BNL-MOX-2009-001

Risk Assessment of Red Oil Excursions in the MOX Facility

V. Mubayi, M. A. Azarm*, M. Yue, W. Mukaddam**, G. Goode**, R.A. Bari, and F. Gonzalez***

Response to the Review Comments
by Dr. Dana Powers

Figure 3-1. Conditions for a red oil explosion to occur

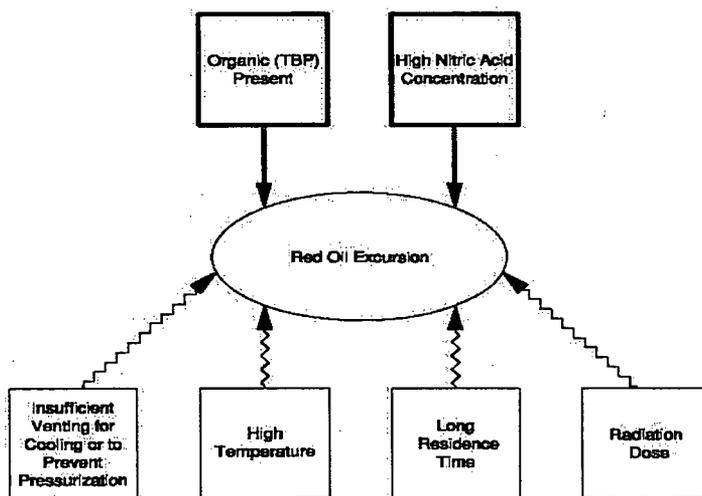
8. The diagram in figure 3-1 specifically neglects radiation dose as a contributor to the formation of red oil. I think this can be misleading. One misleading comment arises immediately following where it is asserted that contact between the solvent or diluent, in this case hydrogenated propylene tetramer, cannot lead to the formation of explosive compounds. This may be true for an idealized system, but radiolytic processes can intrude. Hydrocarbon radiolysis has not received the attention that has been devoted to water radiolysis. Hydrocarbons can still undergo reactions including the formation of unsaturated and even oxygenated species. There does not appear to be abundant data for the diluent to be used here, there are data for diluents used in the past. Most troublesome is the radiolytic formation of alkenes that can subsequently react with radiolytic species such as ozone or peroxide.

Figure 5-8. Slab settler dimensions and locations of the levels of the light and heavy phases.

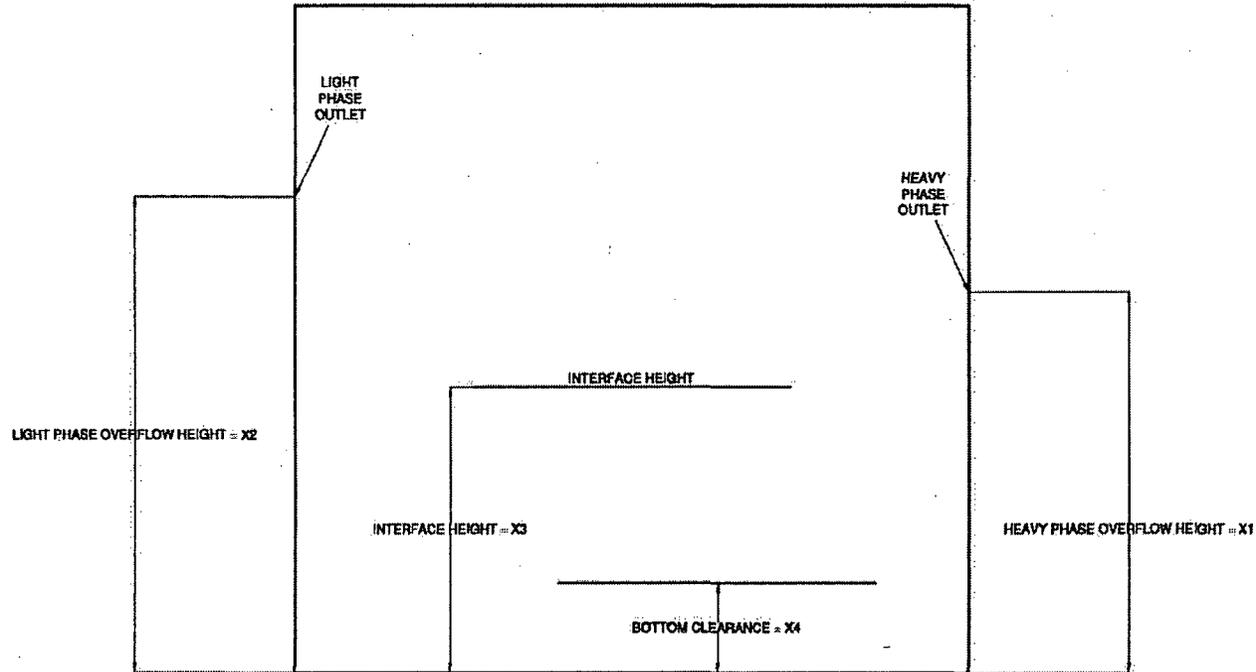
43. Figure 5-8 is essentially unreadable. If you puzzle out the figure, it really does not help to understand the equation. Terms need to be better defined in the equation. Table 5-2 is a mystery. What are the cases being examined here?
